## Alternative Replacement Clutch Design To Fit In Place Of Self Adjusting Types

CLTB 0018

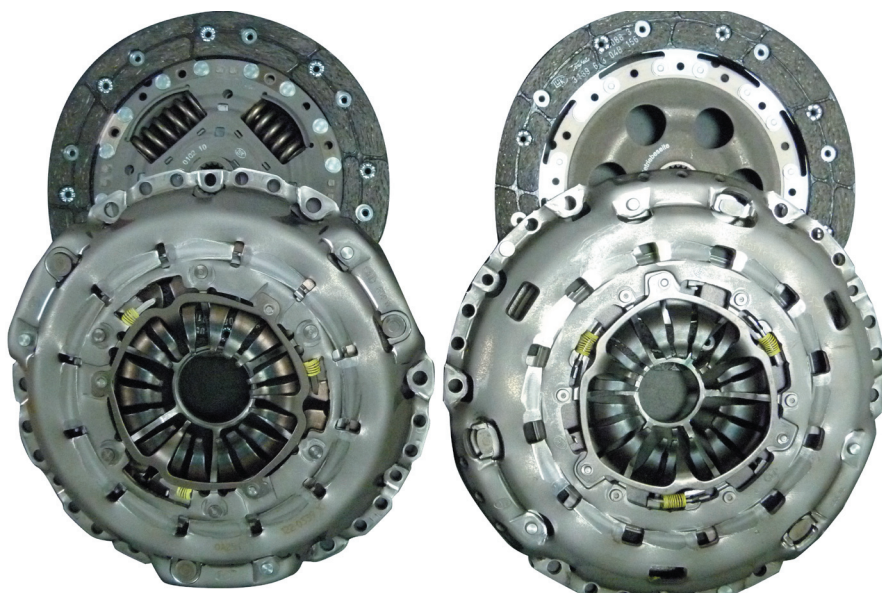
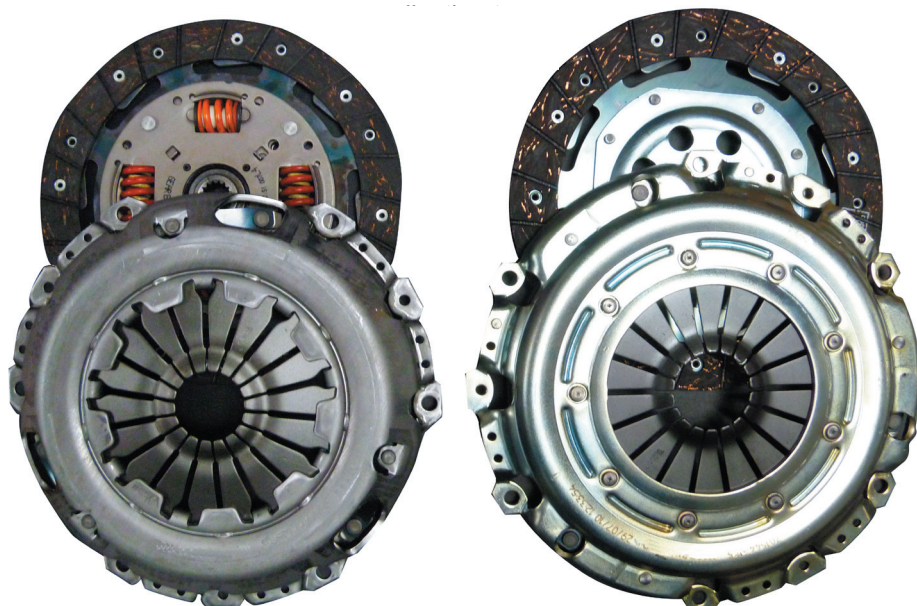
The alternative design clutch kits below have been developed to replace the original self adjusting types above. Although these clutches are different in design, they will fit perfectly in place of the original ones. This has been achieved by using re-designed clutch cover assemblies and driven plates which are fitted with superior low level wear facing material. This gives improved service life which reduces the normal increase in pedal load, thus consequently reducing the requirement for the clutch to be a self adjusting type.
